Tax ID # 04-375076
ON-SITE SEWAGE DISPOSAL SYSTEM
HOWARD COUNTY HEALTH DEPARTMENT
BUREAU OF ENVIRONMENTAL HEALTH

SUBDIVISION: Florence Vista LOT NUMBER: 4

ADDRESS: 2925 Florence Road PROPERTY OWNER: Zhangshi Yin

NON-SDP RESIDENTIAL PLOT PLAN
LOT 4
FLORENCE VISTA
(MDR PLAT #21364)
2925 FLORENCE RD.

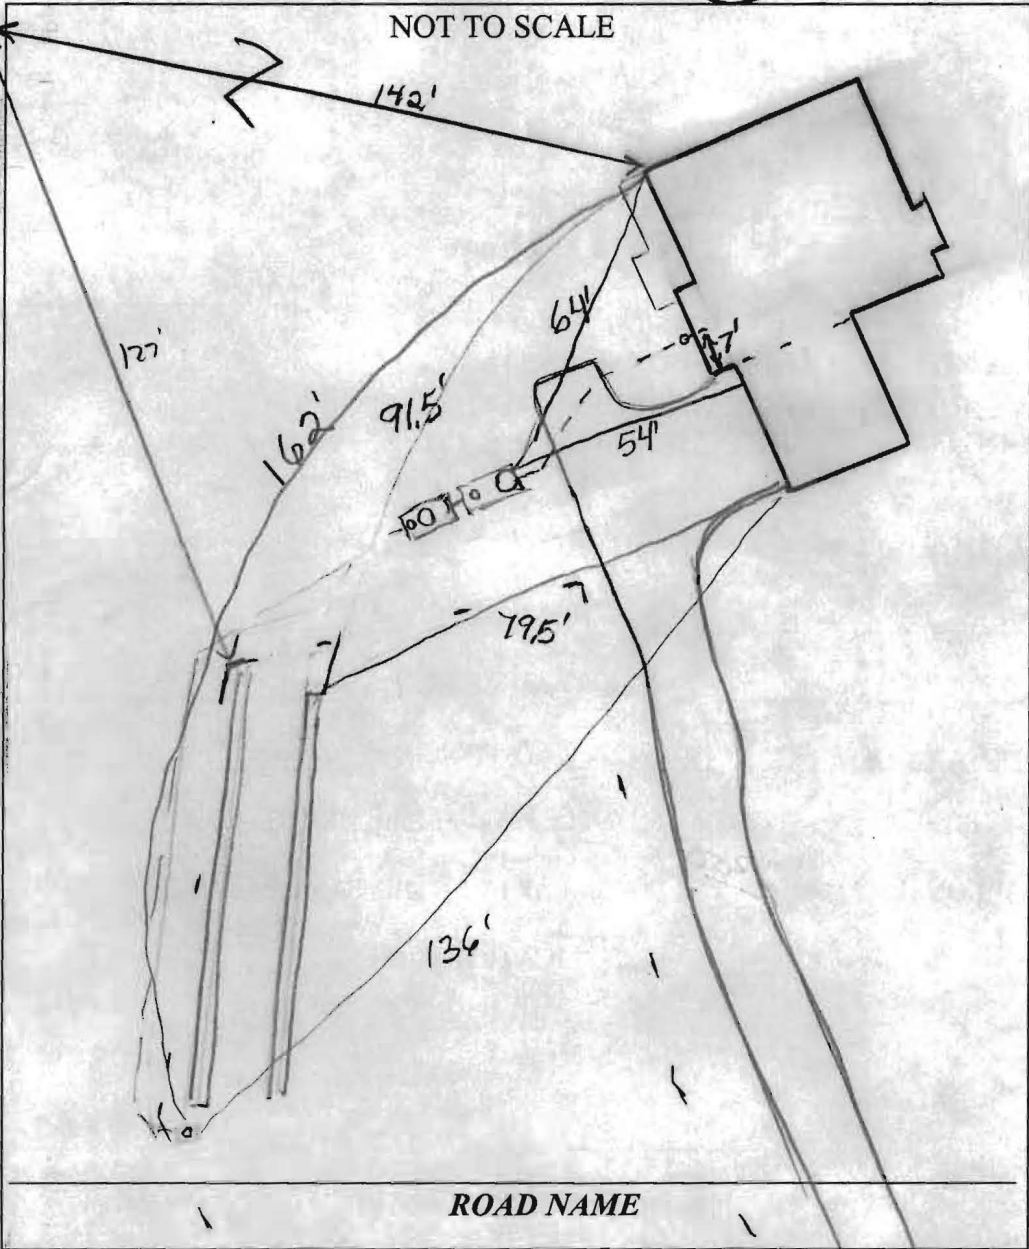
PUMP CHAMBER CAPACITY (GALLONS): ~~1000~~ 1250 COMPARTMENTED TANK REQUIRED

SQUARE FOOTAGE OF HOUSE: 2,100 * Ejector pit ok'd by homeowner.

LINEAR FEET OF TRENCH REQUIRED: ~~103~~ 140' 2' wide 3-6.5' 2x70' ~63 ton

TRENCHES:	Trenches to be 3.0 feet wide. Inlet is at 2.5 feet below original grade with 2.5 feet of stone below the distribution pipe. Bottom maximum depth is 5.0 feet below original grade. Effective sidewall begins at 3.0 feet below original grade. Maintain at least 9.0 feet of spacing between trenches. ~52 ton
LOCATION:	Set septic tank per plan. Set distribution box at top corner of septic easement. Install 1 x 100' trench on contour. Basement will not sewer by gravity.
NOTES:	Do not order the septic tank until after layout inspection and Sanitarian approval. Stake easement corners. Call for layout inspection. Mark utilities. Gravel tickets must be available for Environmental Sanitarians. Stone must be approved by the Howard County Health Department. A written variance request is required for tanks deeper than 3 feet. A traffic bearing lid is required for tanks deeper than 4 feet.

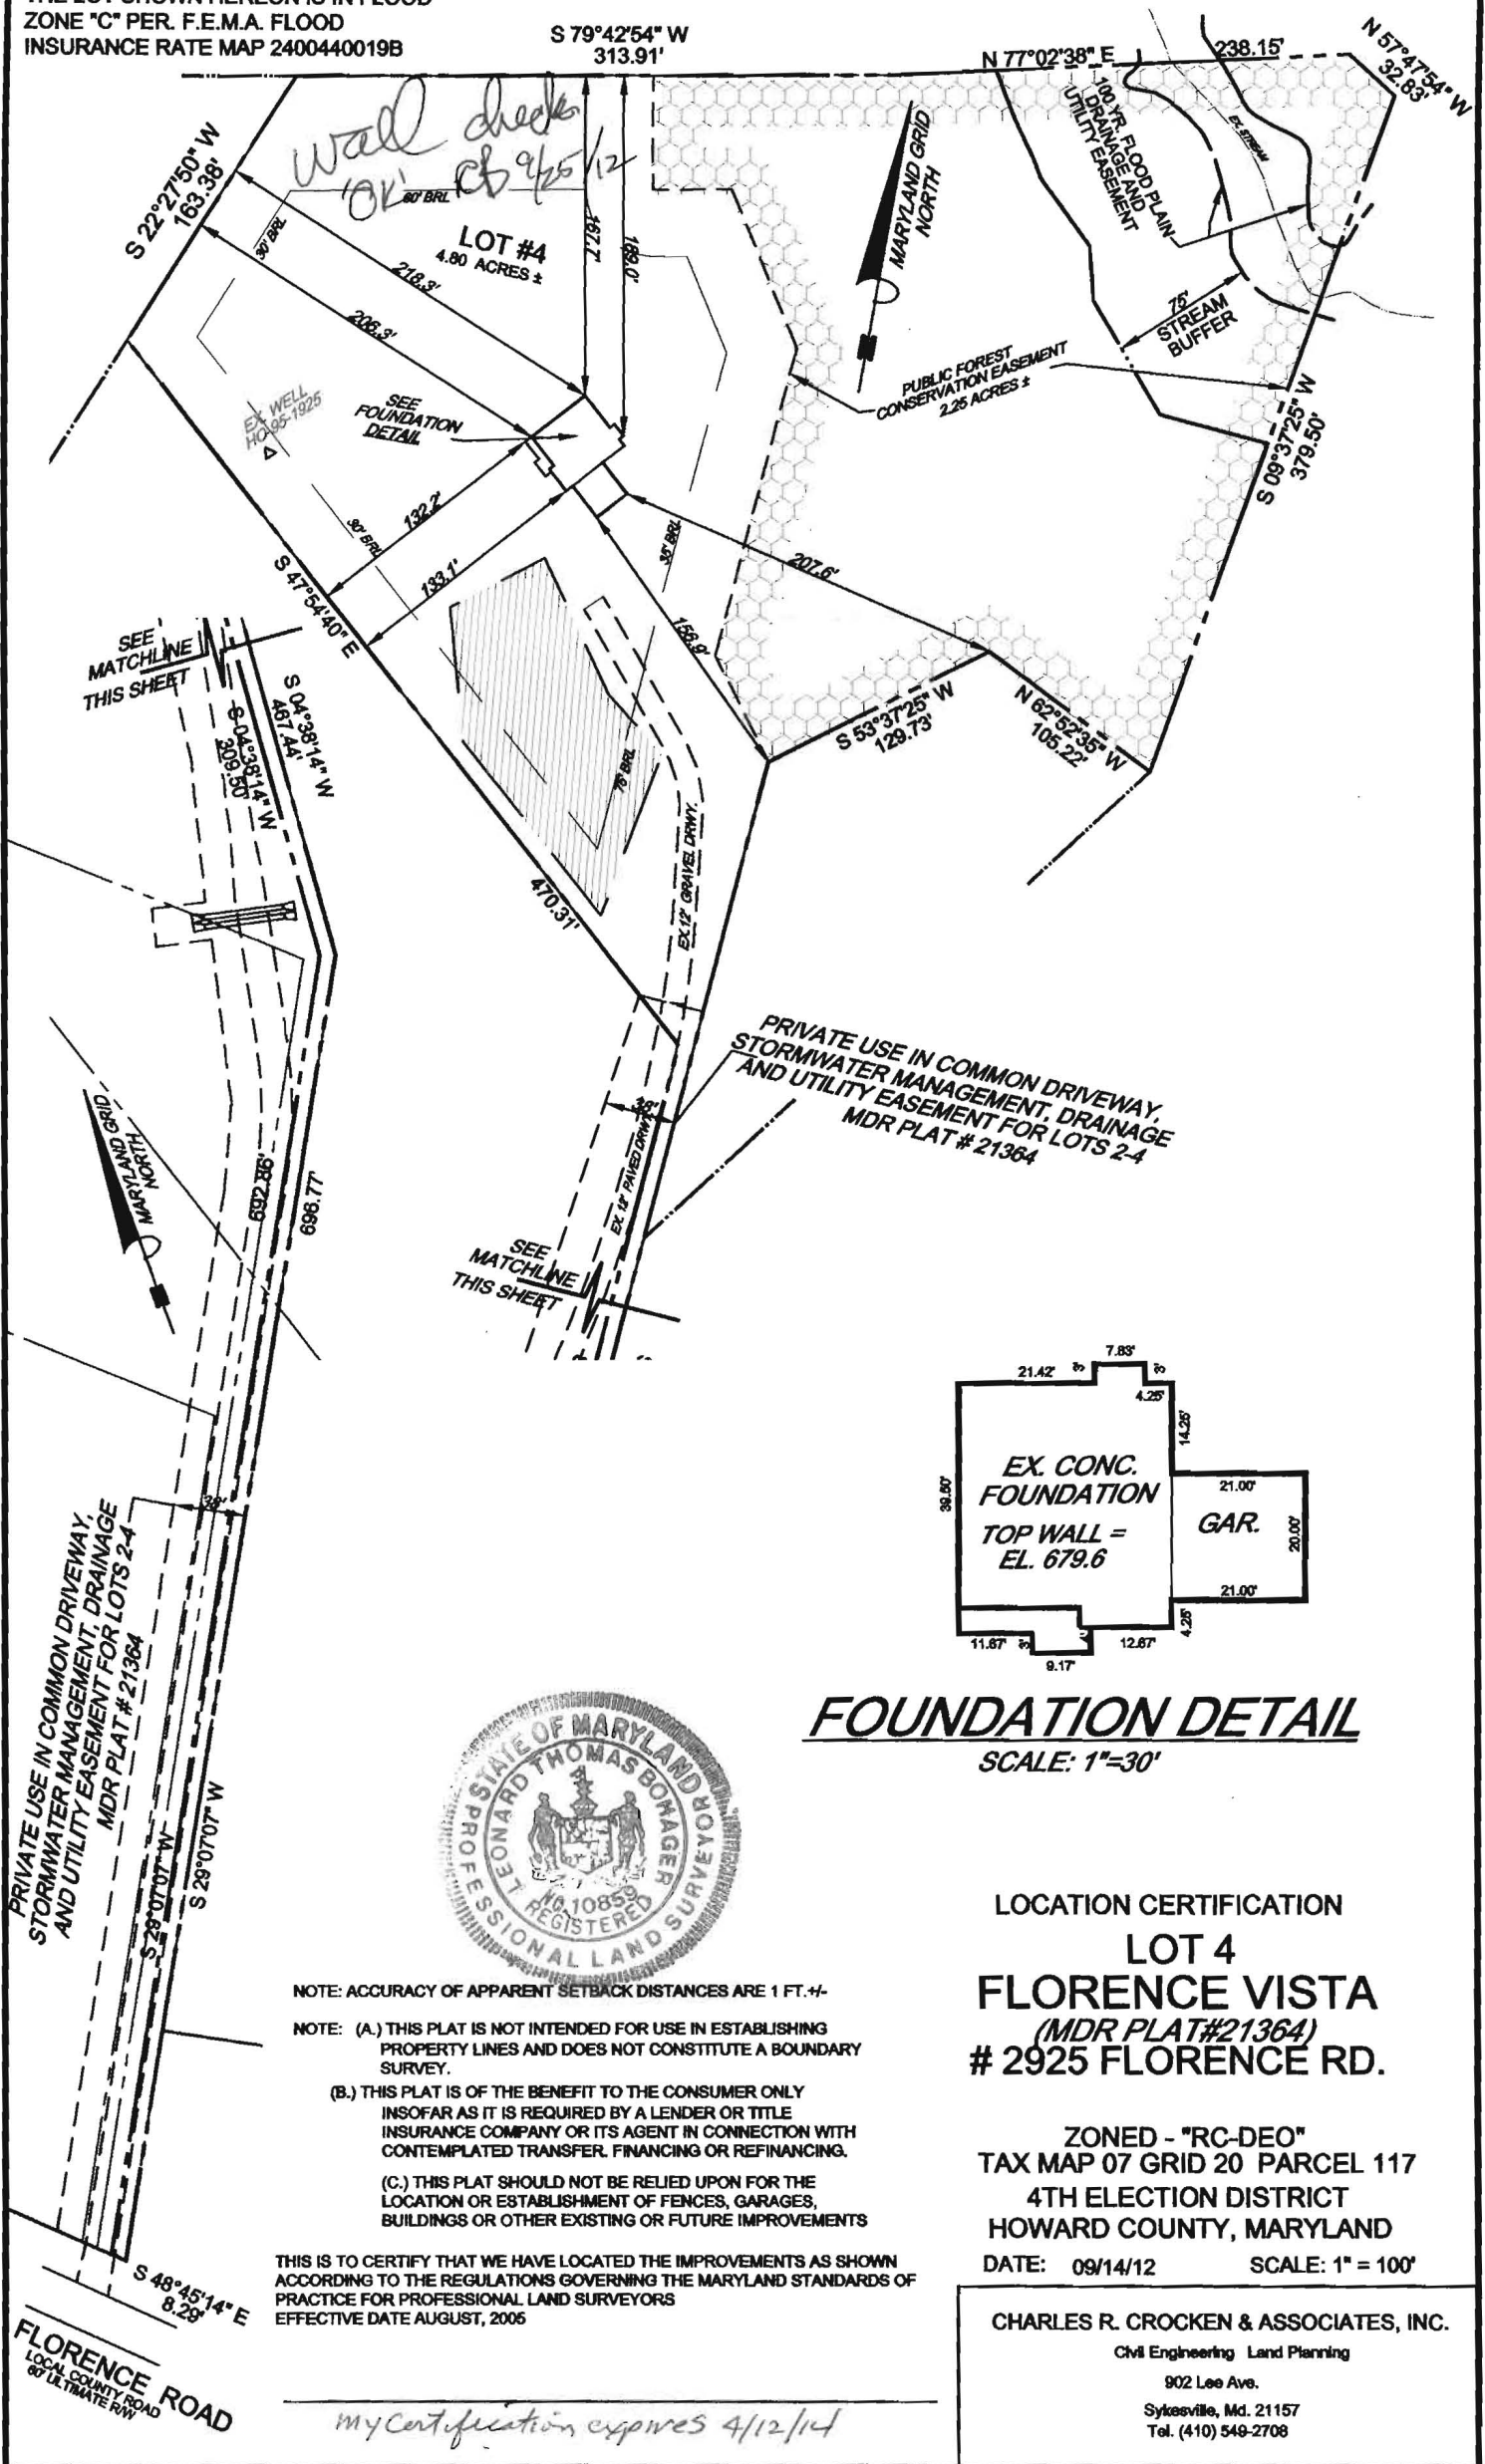
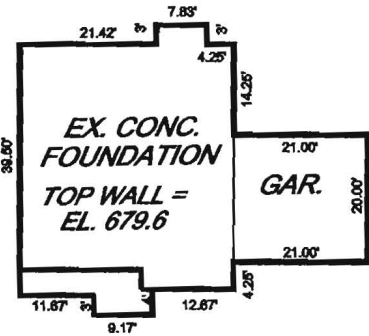
10/9/12 Tanks are to be set in front of house towards SRA. Maintain no more than 3' of cover on tanks. set D box @ top corner of SRA. Run 2x70' trenches on water back towards house. Ejector pit required in house. spec checked on permit (initials)

System covered by contractor. He thought it had already been inspected. Got what measurements I could. Need pump and alarm test. (initials) 1/7/13 Pump test ok. Alarm not set on dedicated circuit. Alarm does function properly.

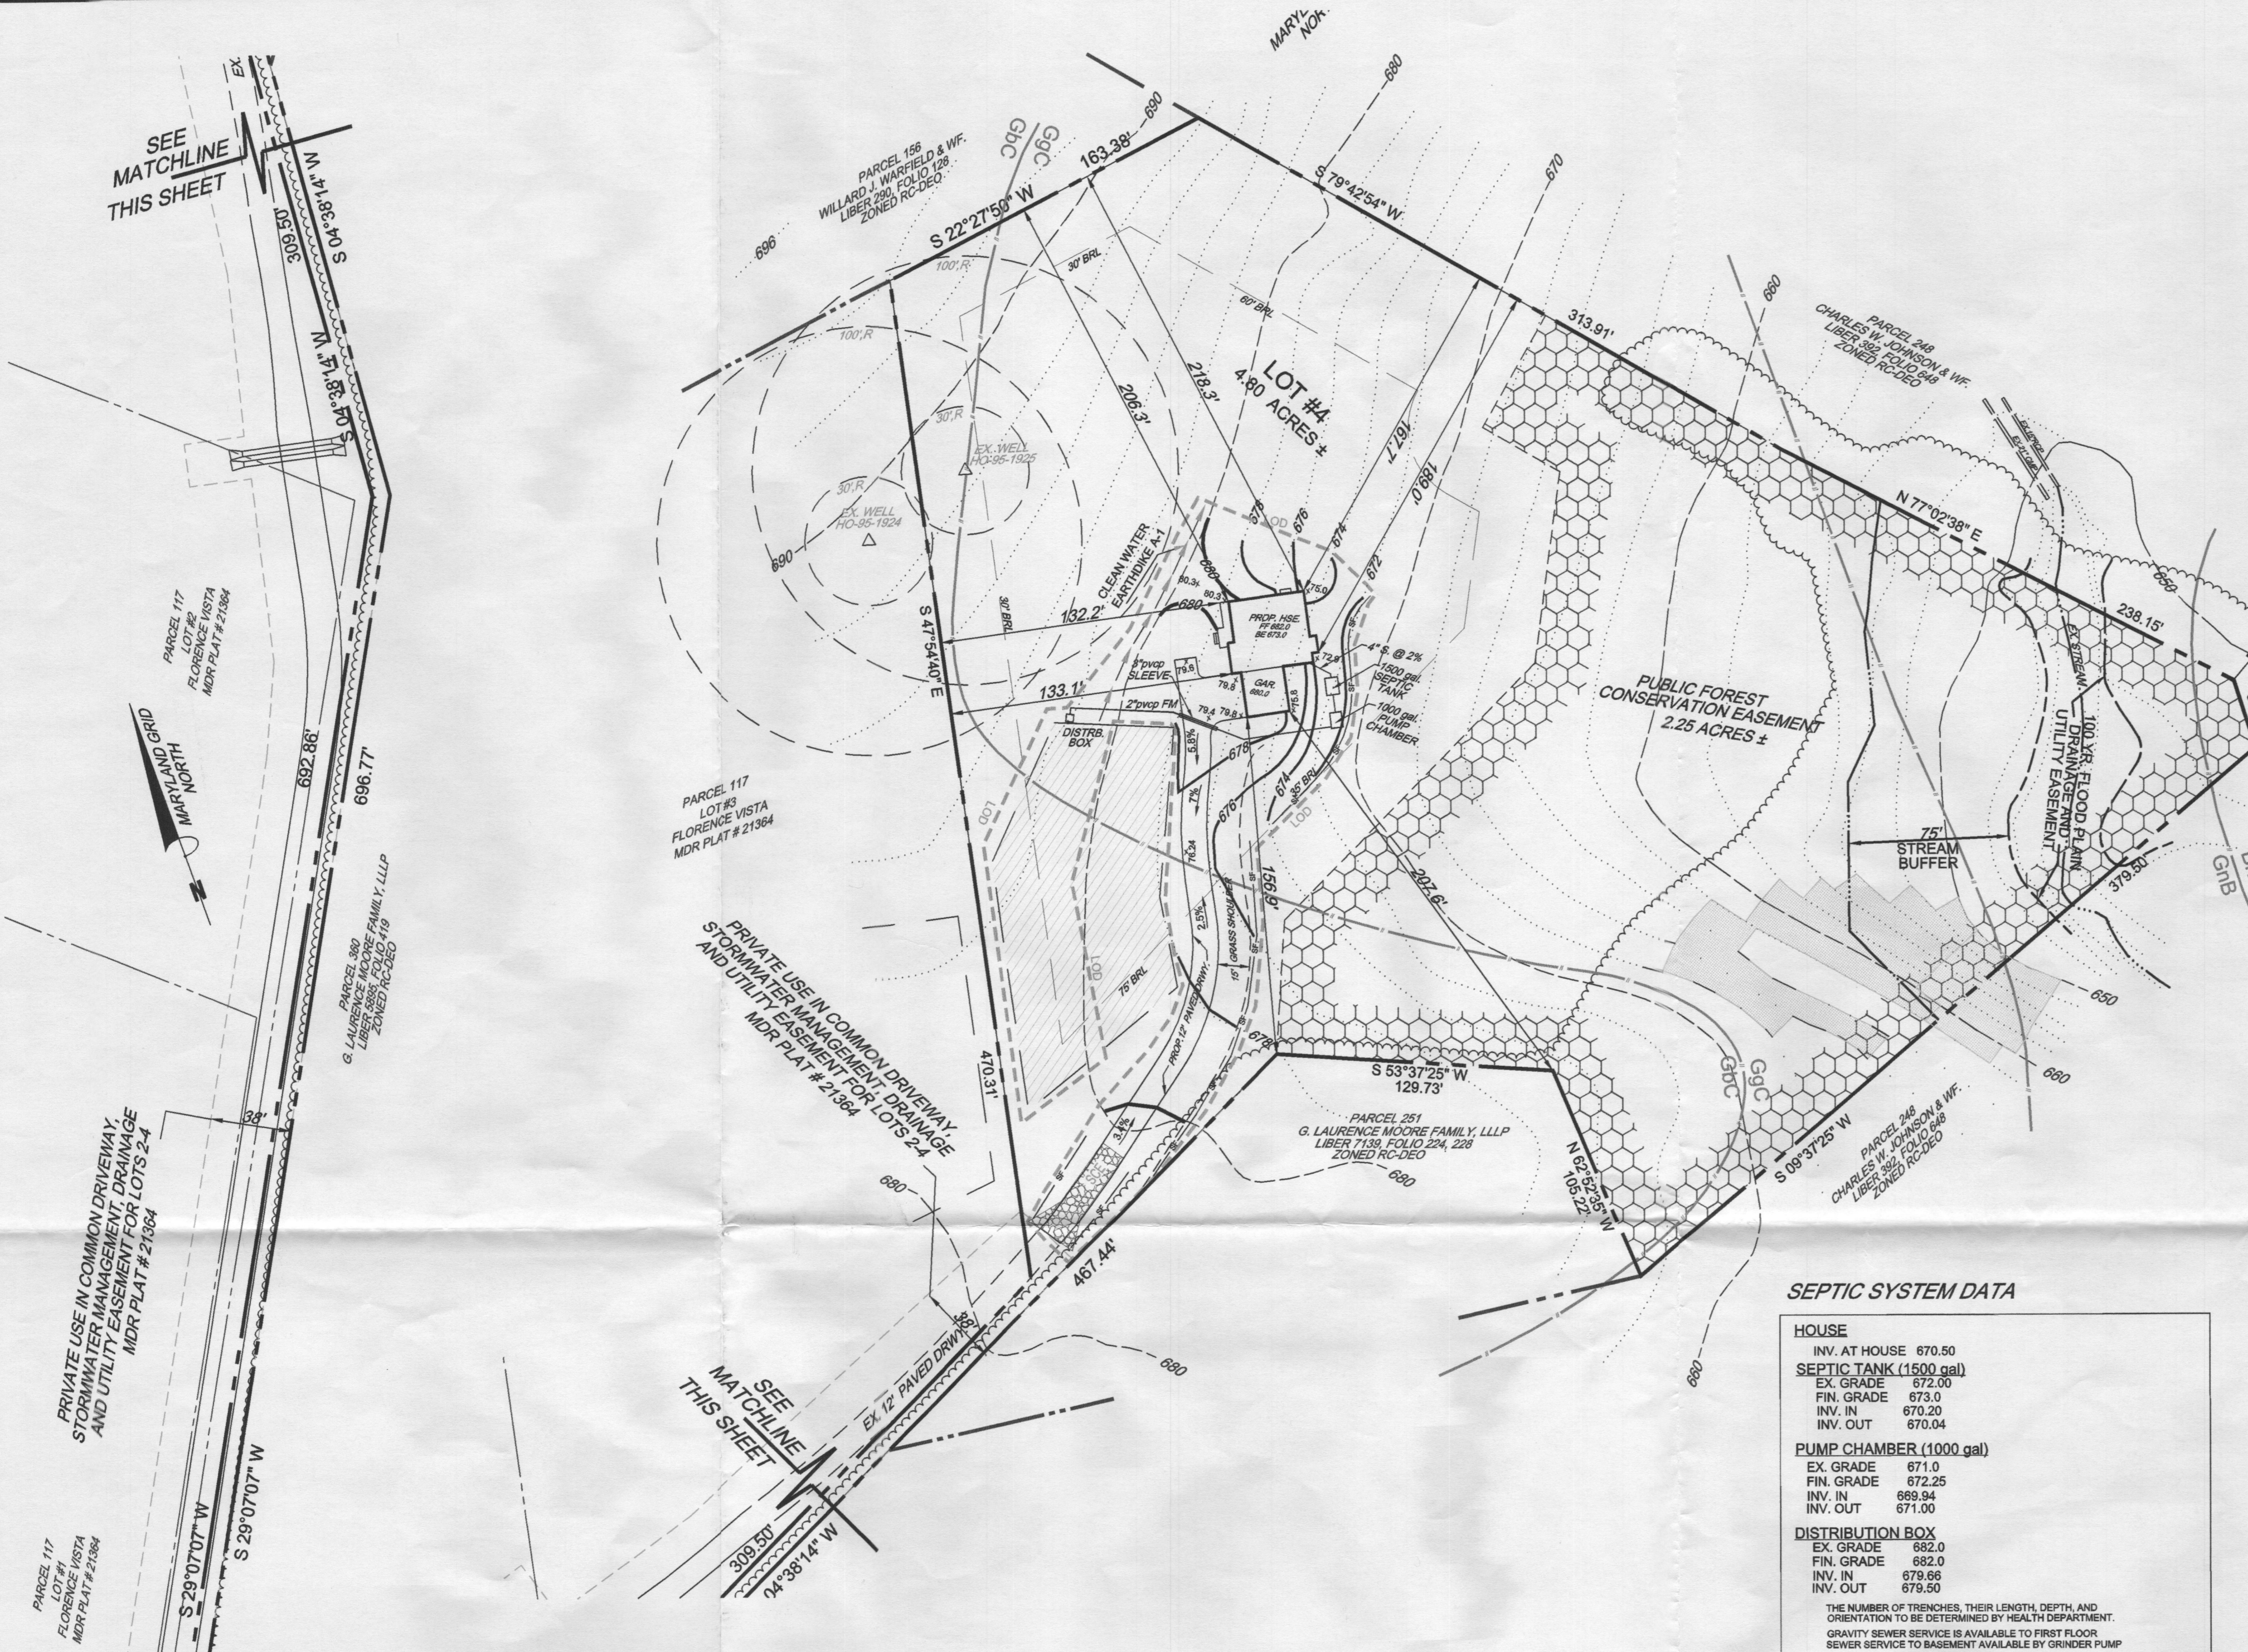
Upon close review, it looks like gravity is not an option to the top. The site plan shows the distribution box stopping several feet short of the top corner of the area, cutting off the top 1/3. We will need the distribution box to be placed in the top right corner of the area, which puts it at 682' elevation at the ground. In order to get gravity from the house, the box would have to be placed at 5.5' depth. That is too deep for the soil conditions you have out there. It starts to get rocky around 5' depth. Our septic specs will indicate that the distribution box shall be placed in top corner at 2.5' depth with a trench inlet at 2.5' and a bottom depth of 6'.

That puts the distribution box at 679.5' elevation, which is higher than the house invert out elevation of 677.7', hence the need for a pump chamber after the septic tank.

We will require the septic system to be installed in the upper portion of the septic reserve. If a house location can be moved to avoid pumping the sewage to that upper portion, we do not object as long as all applicable setbacks are met. We will review the house location on a building permit site plan to determine if it is acceptable. A building permit site plan also must include the proposed location of the septic tank and distribution box with elevations, so we will be able to determine if gravity flow is obtainable or if a pumped system is necessary before signing off on the building permit.
